ADDENDUM #3 TO
MONTANA DEPARTMENT OF TRANSPORTATION
INVITATION FOR BID
#HWY-309727-RP

The purpose of this addendum is for the 3rd Approved Equals Request for Exceptions for the 35-Passenger Over the Road Mid-Size Coach Vehicles.

TYPE OF VEHICLE/EQUIPMENT: 35 Passenger Midsized Coach

FLOOR PLAN:

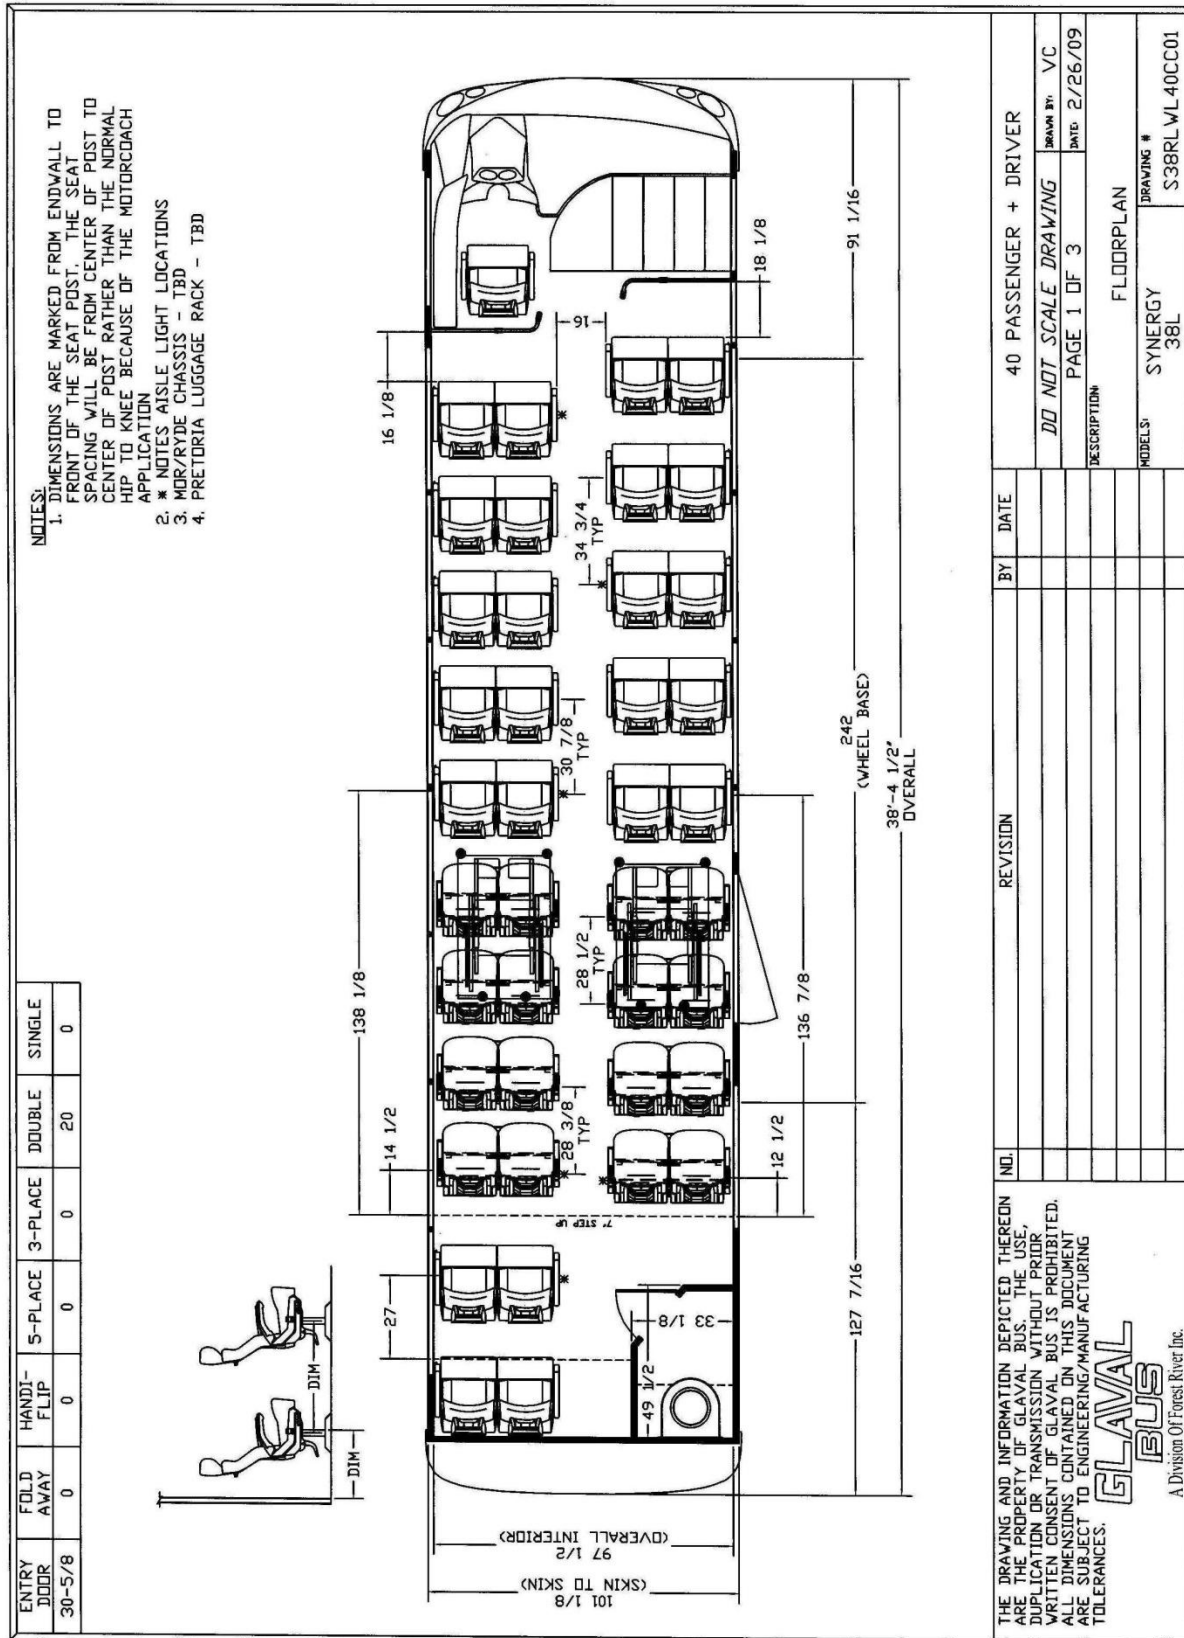
Please approve these changes to the 35 passenger midsized coach bid. We appreciate your agency's attention and please contact me if further information is needed.
